UNITED STATES PATENT AND TRADEMARK OFFICE

Advisory Action

10/091,502

CHE ET AL.

FIG. 1

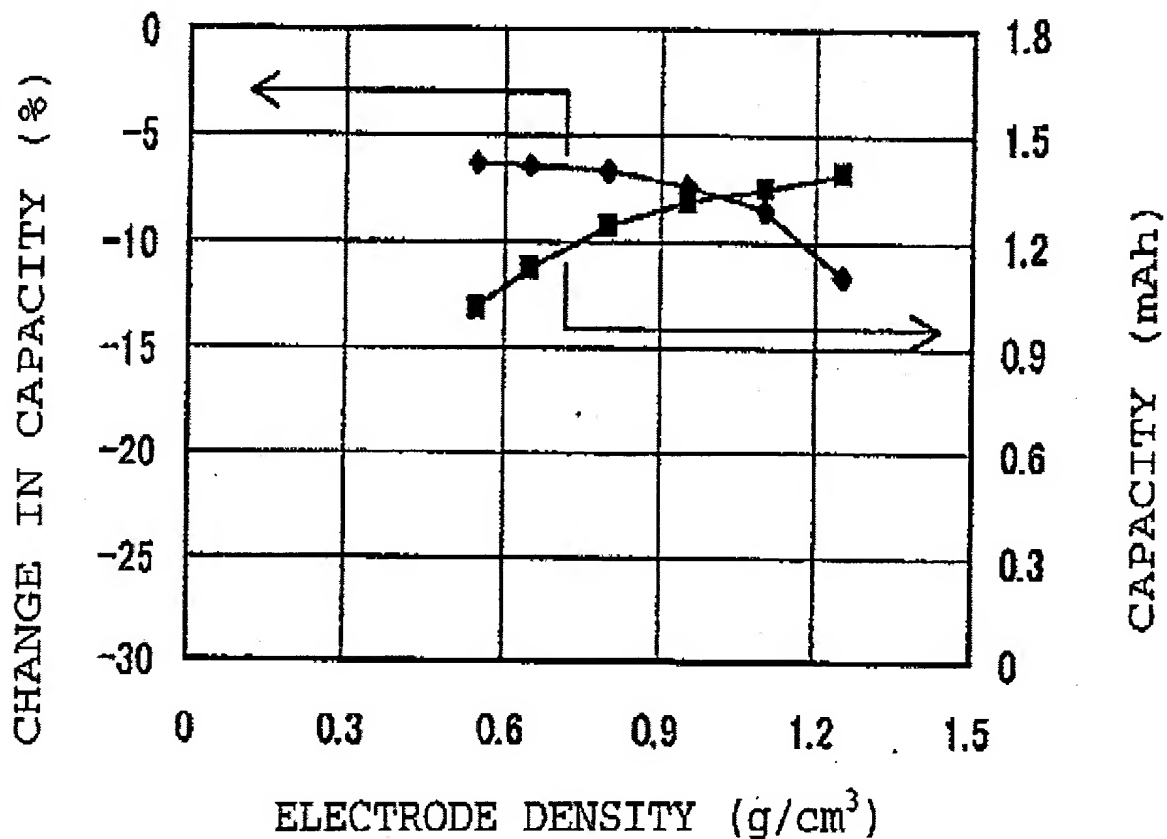
Furthermore, the objective evidence of nonobviousness is not commensurate in scope with the instant claims which the evidence is offered to support. For instance, it is noted that data of Figure 1 showing improved capacity and cycle reduction characteristics does not evidence unexpected results for the entire claimed range of 0.6-1.2 g/cc or 0.7-1.0 g/cc because as apparent from **Figure 1** below, significant initial capacity of more than 1.2 mAh is reached at negative electrode densities greater than about 0.8-0.85 g/cc (not 0.6 g/cc or 0.7 g/cc as instantly claimed) and significant reduction in capacity of more than 7 % (assuming that 7 % is an acceptable reduction) are observed at negative electrode densities as low as about 0.9 – 0.95

g/cc or higher (not 1.0 g/cc or 1.2 g/cc as instantly claimed). For that reason, it is contended that the objective evidence of nonobviousness is not commensurate in scope with the present claims.
